Staff Report

To: Salt Lake City Planning Commission
From: Eric Daems, Senior Planner, eric.daems@slcgov.com, 801-535-7236
Date: August 24, 2022
Re: PLNPCM2022-00422, 370 S West Temple

Design Review

PROPERTY ADDRESS: 370 South West Temple Street
PARCEL ID: 15-01-428-026-0000
MASTER PLAN: Downtown
ZONING DISTRICT: D-1 Central Business District

UTILITIES DESIGN

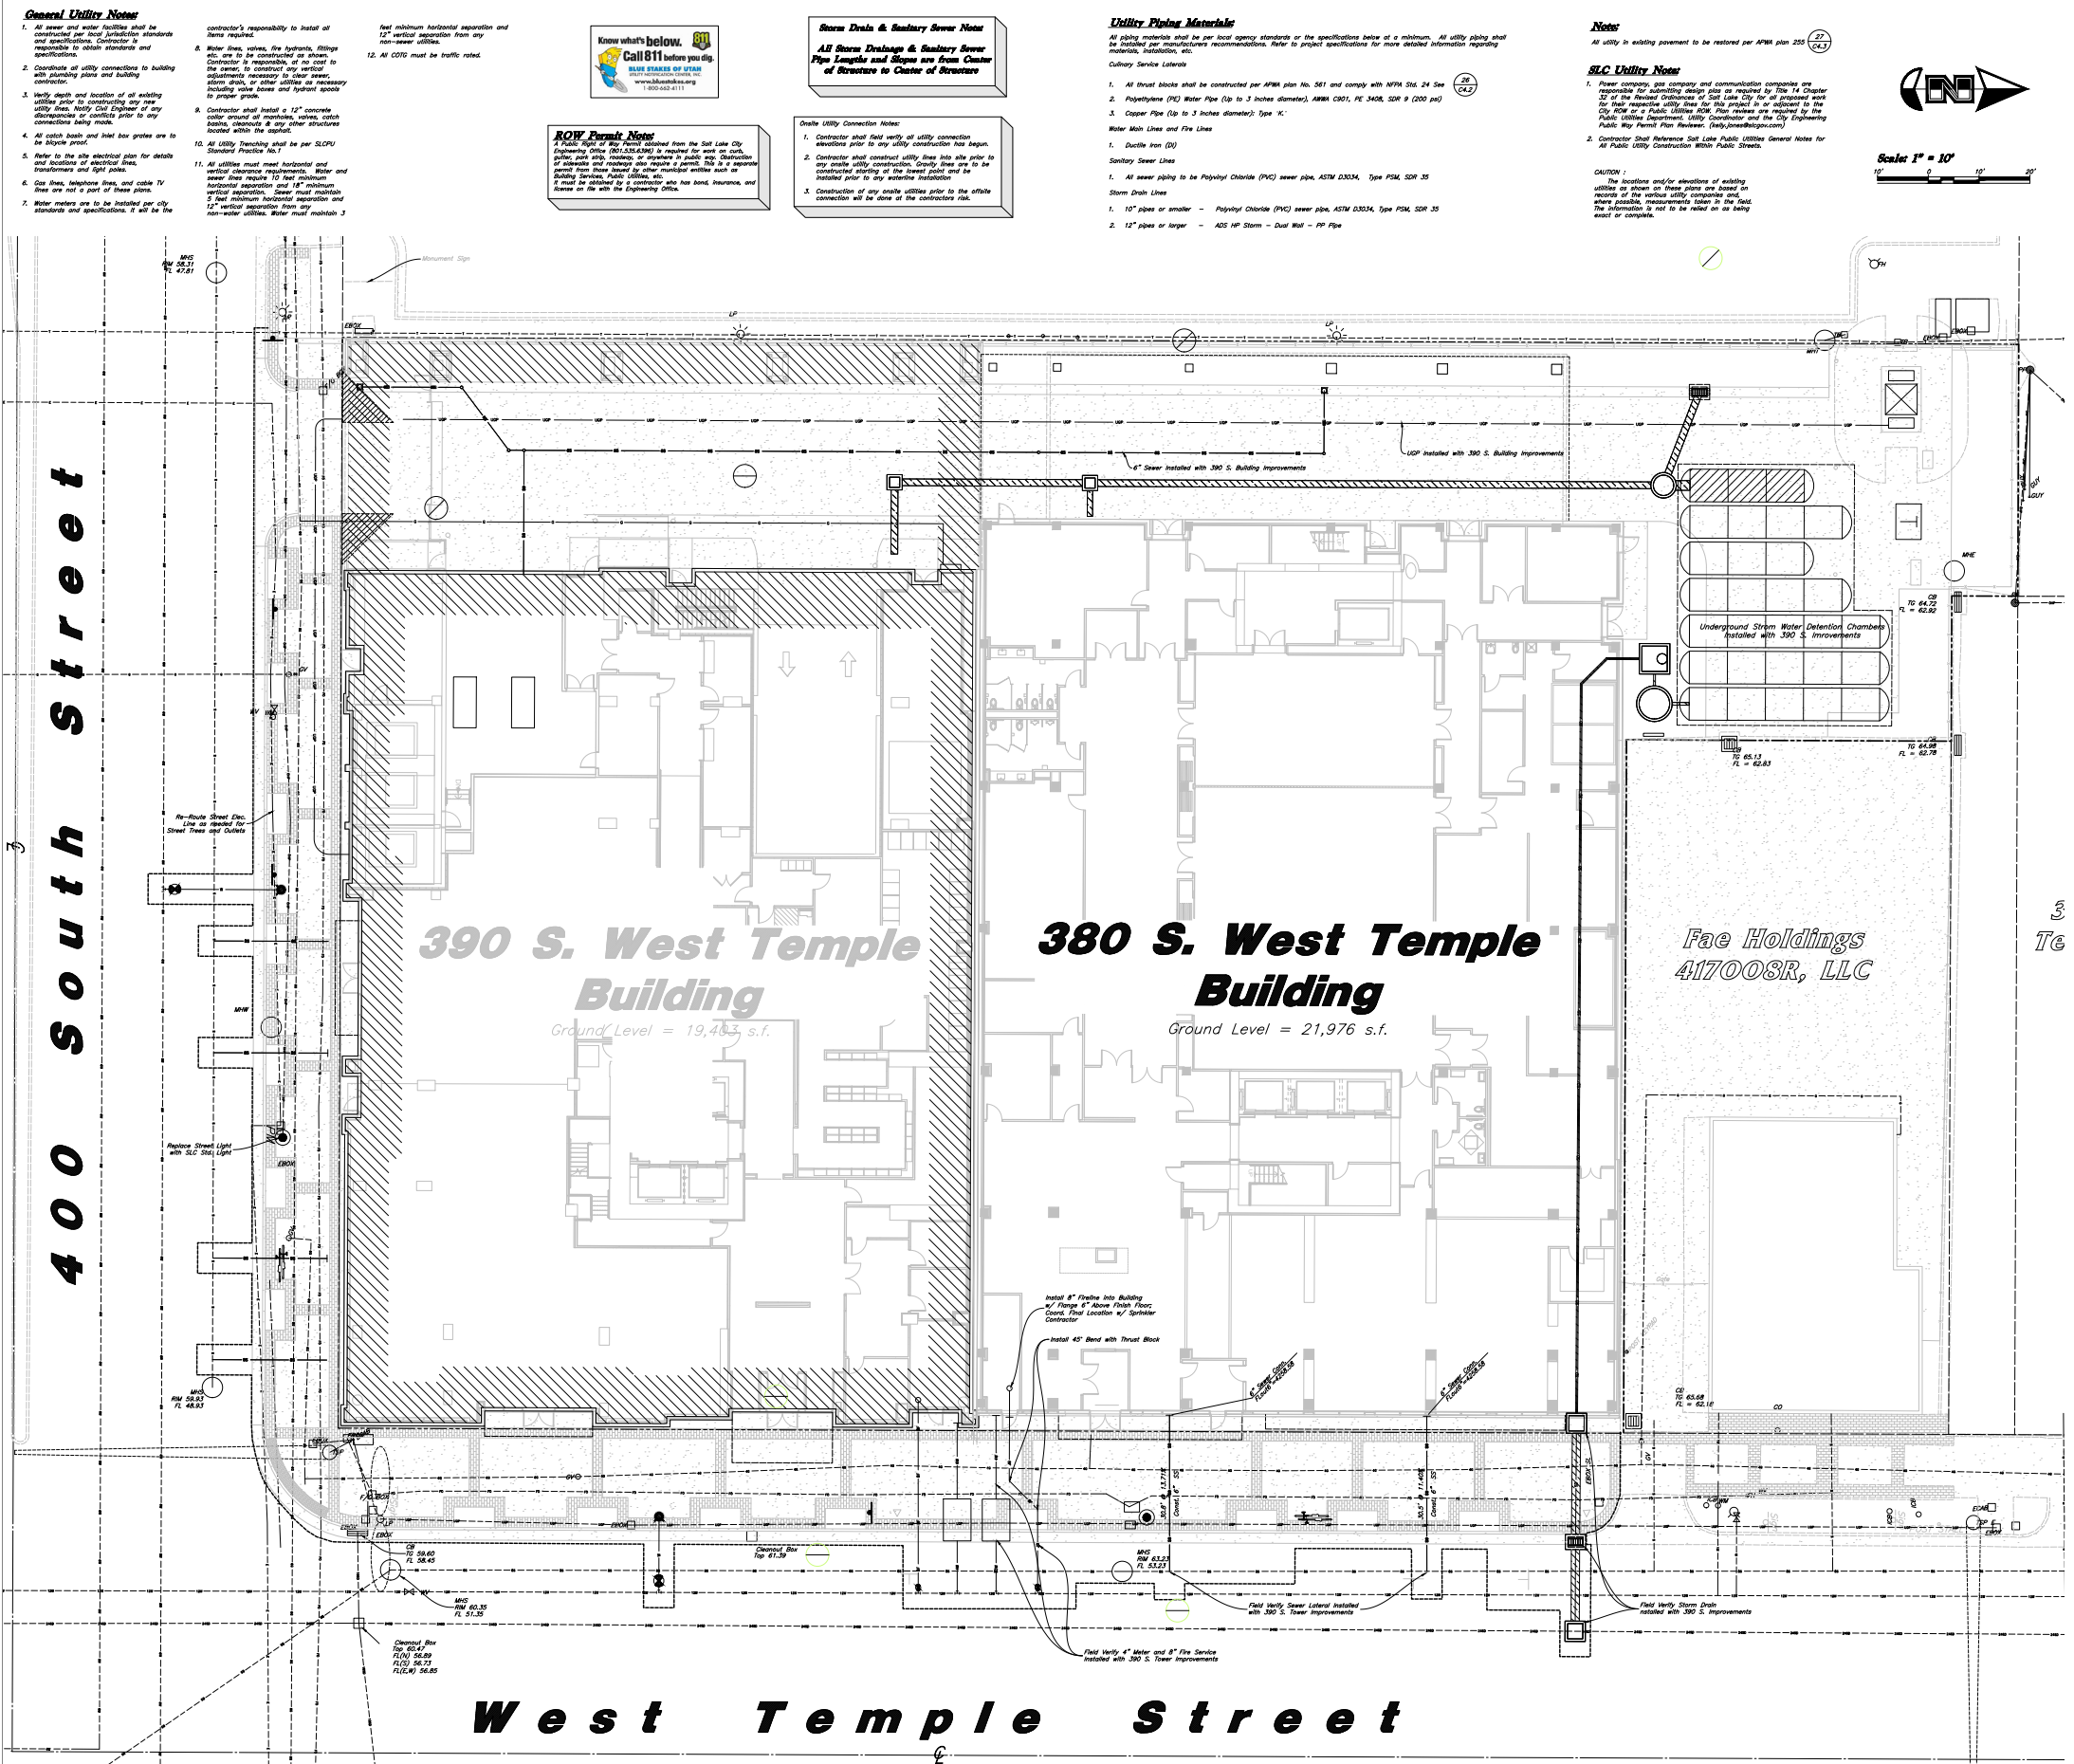
- No utility objection to the proposed height exception.
- However, the applicant should be aware that the increased density and impact to the system will likely require the water mains in 400 South to be upsized as well as potential sewer system upgrades.
- This project will require a complete technical drainage study.
- Stormwater requirements include retention of the 80th percentile storm and Green Infrastructure/LID treatment of stormwater as well as detention of the 100 year storm event.
- Site planning should consider the stormwater requirements.

- Site planning should consider the location of utility vaults and infrastructure including transformers, grease interceptors, meters, etc.
